11 March 2025

*Re: 146 – 150 Bridport Street, Albert Park
Proposed permit amendment*

1 DETAIL PLAN - RESIDENTIAL ENTRY
TP.1100 1 : 20

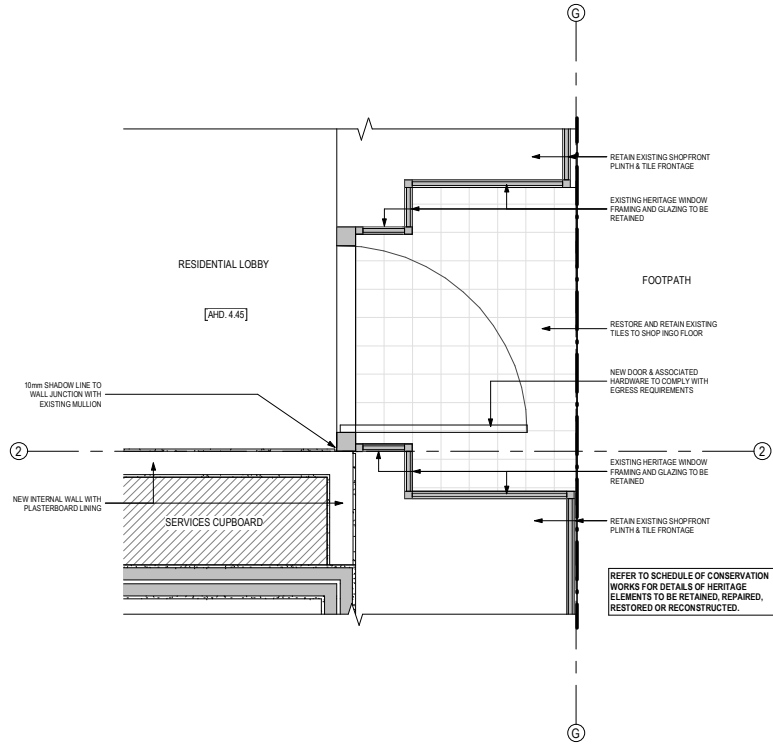
It is noted that the apartment entrance has been relocated to the shopfront of number 146. However, the shop front is still to be retained in full and the junction between the existing shop front and a proposed new internal wall is sensitively managed by butting into the existing door mullion (refer to the detail prepared by Cera Stribley Architects appended to this letter). It is noted that the existing door will need to be replaced due to code compliance requirements, but it is intended this will be done utilising details that correspond with the character of the existing pair of doors.
